Project	<b>IEEE 802.16 Broadband Wireless Access Working Group</b> < <a href="http://ieee802.org/16">http://ieee802.org/16</a> >	
Title	<b>Replacement Figures Mentioned in TG1 Comments</b>	
Date Submitted	<b>2000-10-27</b>	
Source(s)	Ken Stanwood Ensemble Communications 9890 Towne Centre Dr. San Diego, CA 92121	Voice: (808) 404-6559 Fax: (858) 638-7142 <a href="mailto:ken@ensemblecom.com">mailto:ken@ensemblecom.com</a>
Re:	New versions of figures for TG1 call for comments.	
Abstract	My comments mentioned new versions of figures that I hold the originals of. This contains the new figures.	
Purpose	For reference to my TG1 comments.	
Notice	This document has been prepared to assist IEEE 802.16. It is offered as a basis for discussion and is not binding on the contributing individual(s) or organization(s). The material in this document is subject to change in form and content after further study. The contributor(s) reserve(s) the right to add, amend or withdraw material contained herein.

# Replacement Figures Mentioned in TG1 Comments

Ken Stanwood  
Ensemble Communications

Figure 51 : Mentioned in comments as file TDD\_DLSubframe.vsd

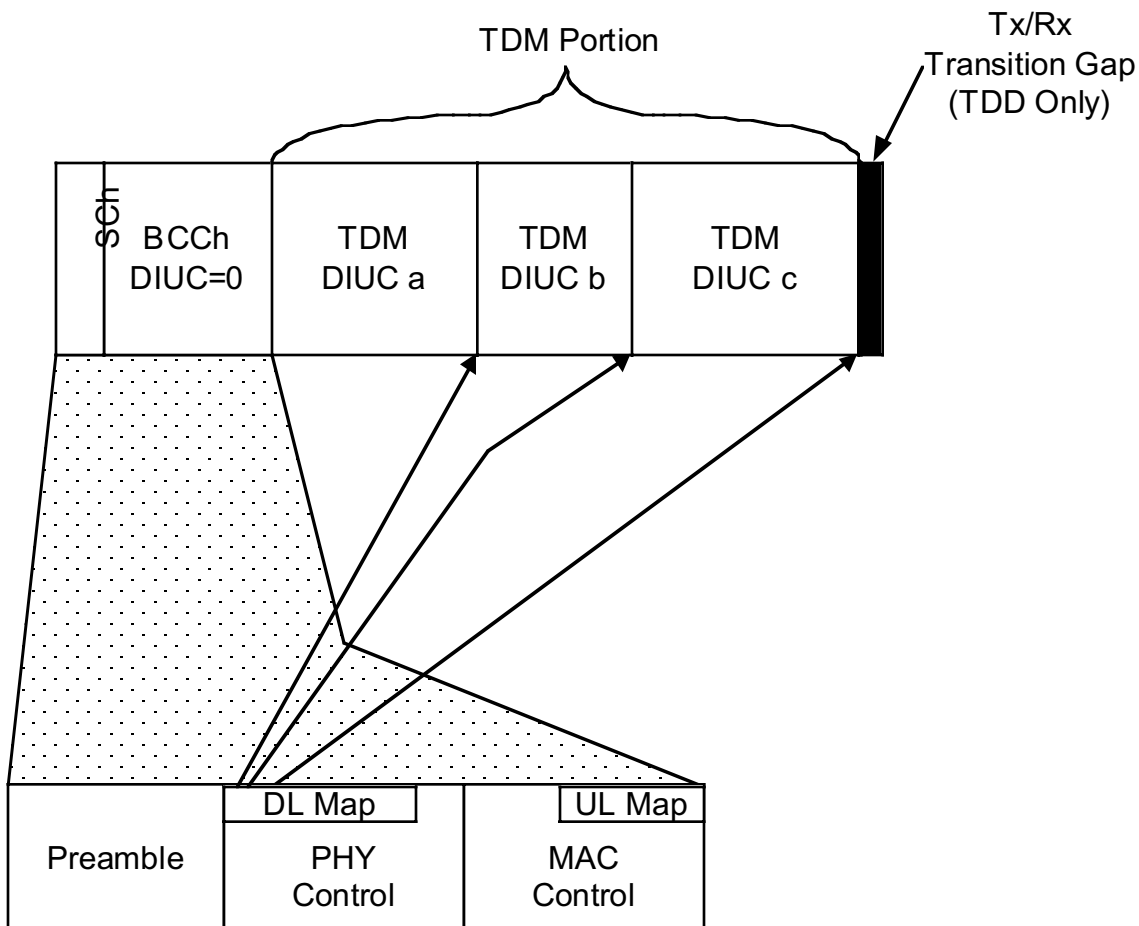
My TG1 comments stated the need to do editorial changes to 4 figures for which I created the originals. The changes are described in my TG1 comments, and are merely editorial. They fall into 2 categories – changing CPE to SS, and showing adaptive burst types rather than merely adaptive modulation. Both are changes that were accepted last meeting, but the Figures still need updated. Since the comments are in text only, this document provides the figures and the files names with which I referenced them in my comment text. These figures have also been sent to the editors as Visio files.
